UNECE EVS-IWG

OICA comments on EVS25-E1TP-0500
EVS #26 meeting
2023

Feedback on Rate of change of pressure

Case 1 : NMC pack with thermal propagation without fire nor explosion nor rupture.
For the pack pressure following the thermal runaway of the triggered cell we have

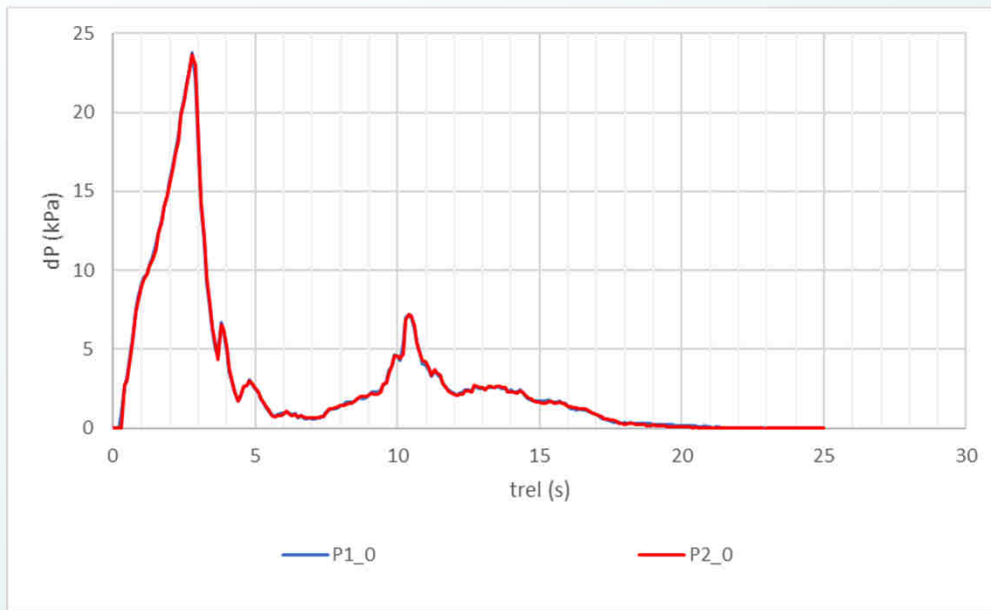
We obtain 240mb peak when the venting valve open.

The derivative of the pressure in mb/s is :

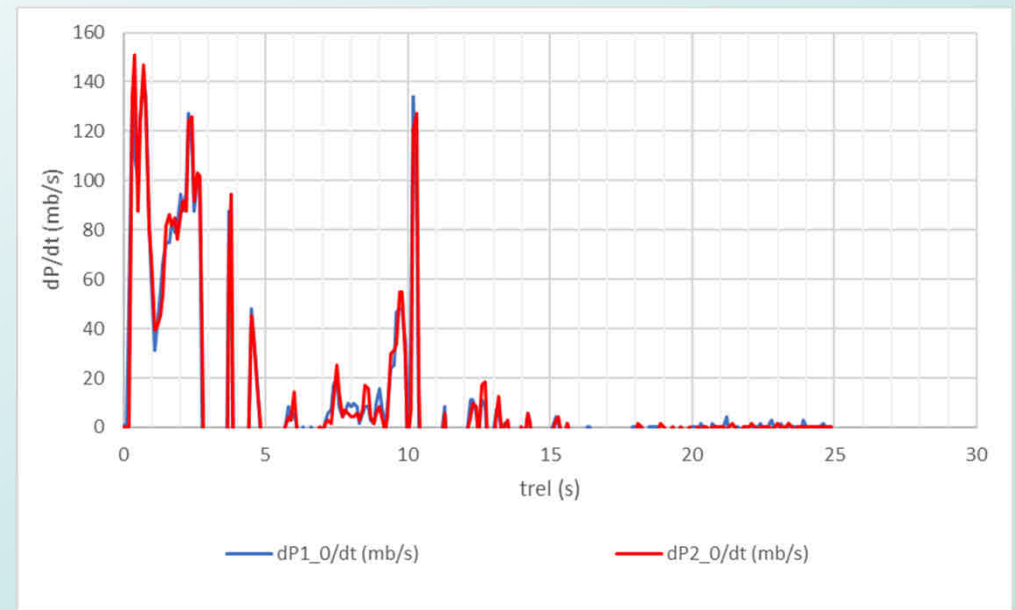
A lot of thin peaks. So $dP_{pack}/dt > 0.01 \text{ bar/s}$ for at least 1s vs 3s to reduce false detection?

Case 2 : For LFP, the behaviour is different. For the pack pressure we have (70mb reversible venting valve in this case):

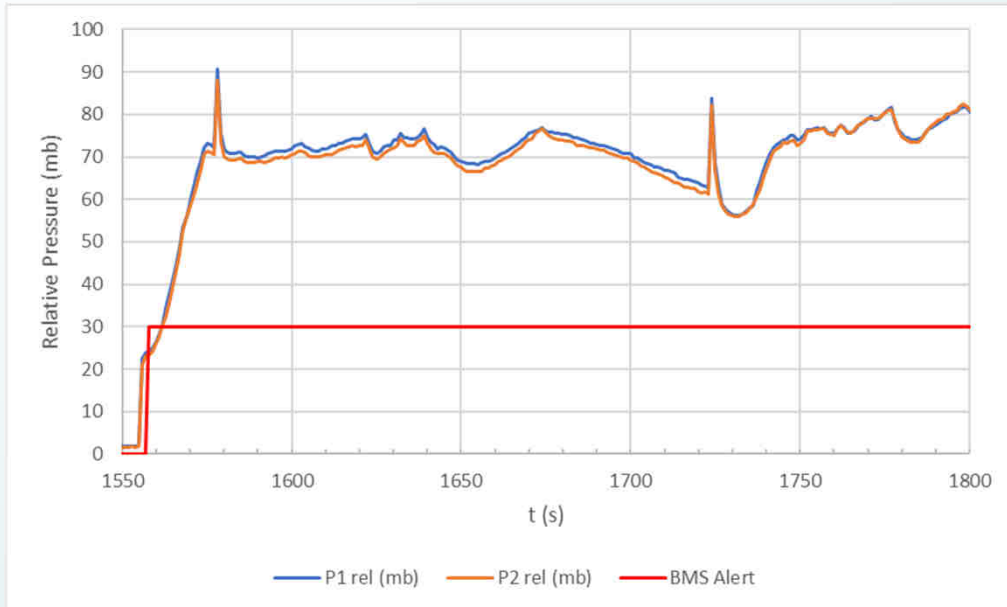
For the pack pressure following the thermal runaway of the triggered cell we have

The degassing phenomenon is much longer than with NMC. During the first seconds the derivative curve dp/dt :

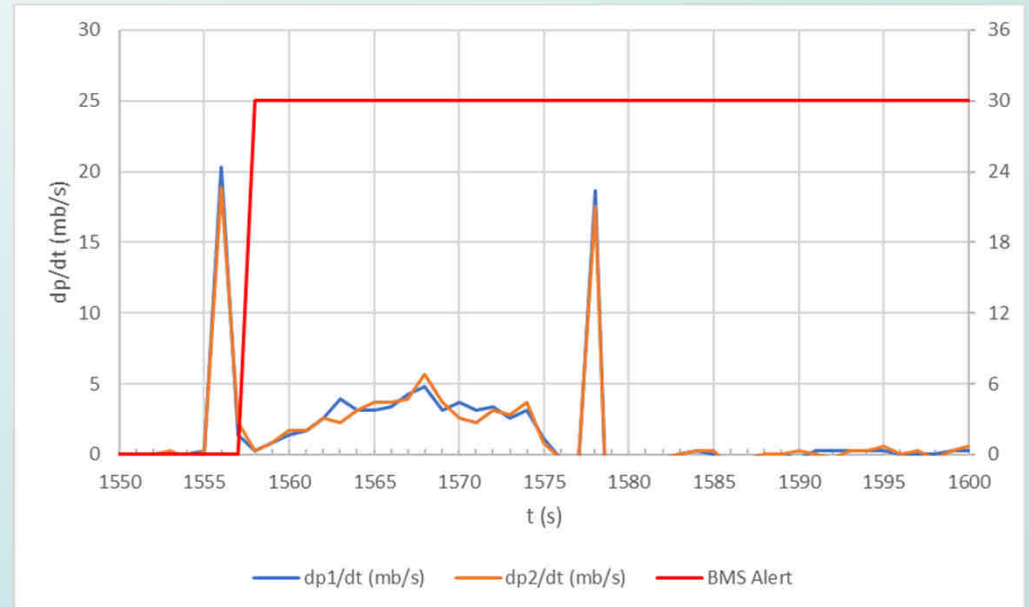
The dp/dt is low.

A criteria $dP_{pack} dt > 0.005 \text{ bar/s}$ during at least 1s for some chemistries could be more suitable ?
